SAFETY RECALL

SR23-82

BAD GPS CONNECTION AT THE VECU CONTROL UNIT
9700 (B13R)

On the vehicles affected by this recall, certain wires of the GPS device were connected to the incorrect circuits. The incorrect electrical installation of the device may cause an accelerator pedal sensor malfunction. In this event, the vehicle could experience an unexpected intermittent or complete loss of motive power.

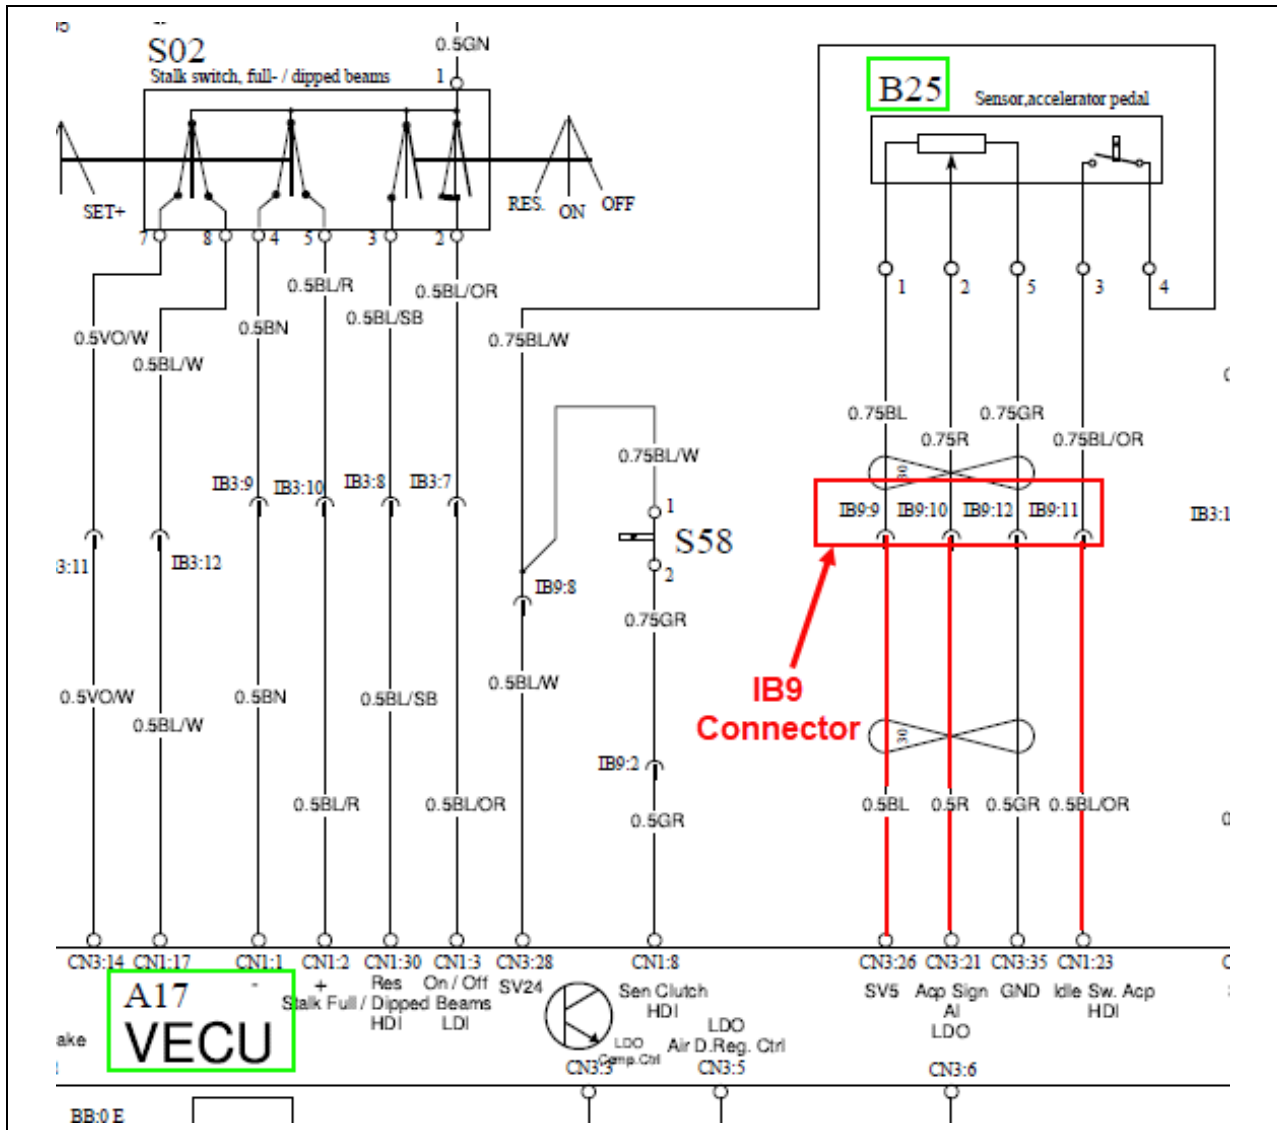
- The bad digital signal connection of the GPS is located between VECU (A17) and the throttle position sensor (B25), therefore; look for spliced GPS wires near the IB9 connector of the power distribution center in the vehicle electrical center compartment.

The digital signal of the GPS can be spliced to the wires located at PIN9, 10 or 11 of the IB9 connector as seen below.

- Once the GPS digital signal is located, remove it from the IB9 connector corresponding wire. This wire of the IB9 connector must be repaired to ensure proper "interference free" signal so the throttle response is back to normal operation. This will also resolve the VECU communication problem with the CAN network.
- Repair the wire using supplied butt splice connector and shrink tubing (solder the connection).

REF BA WIRING DIAGRAM

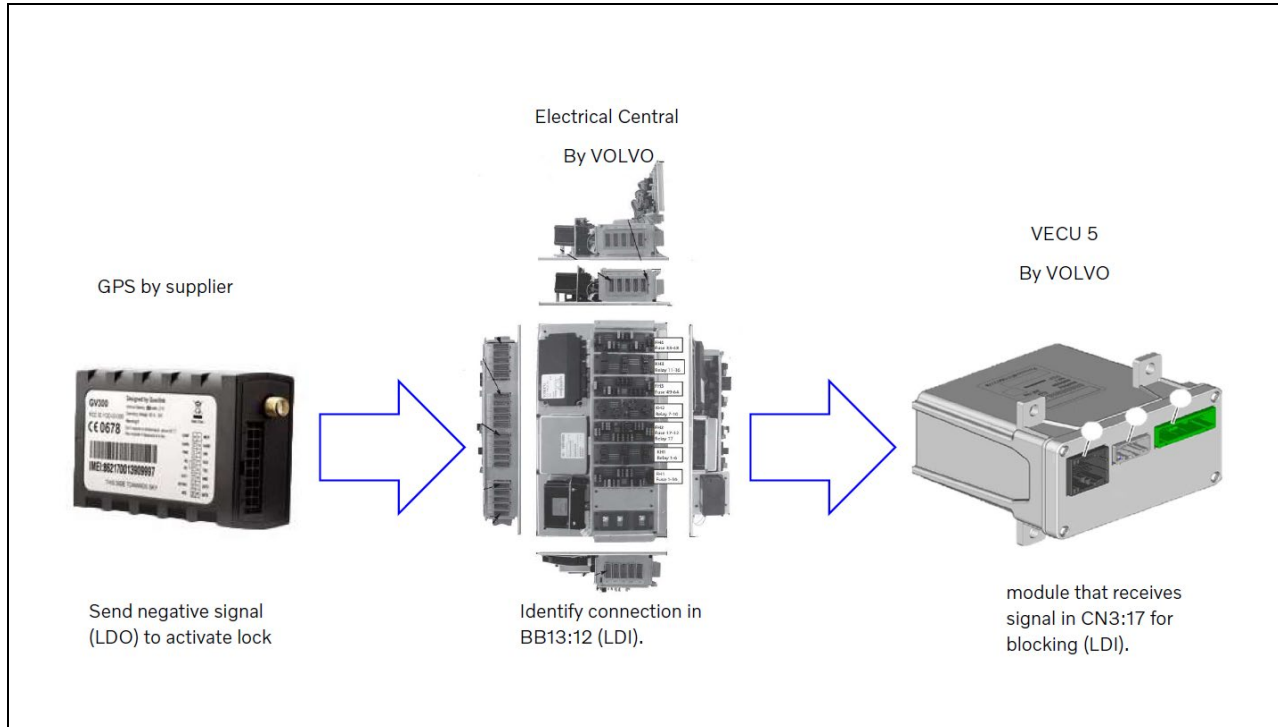
- Connect the GPS negative signal to the VECU.
 - The GPS must send a negative LDI signal(-) from the power distribution center located in the vehicle electrical center compartment to the VECU vehicle control module.
 - To send the correct GPS signal, the GPS signal wire must be connected to PIN12 of the power distribution center BB13 connector (BB13:12). This connection will send the signal to PIN17 of the VECU control module CN3 connector (CN3:17 see wiring diag. BA).

NOTE
 Connect the GPS negative signal wire to the power distribution center using supplied wire and terminals (use shrink tubing and solder the terminals)
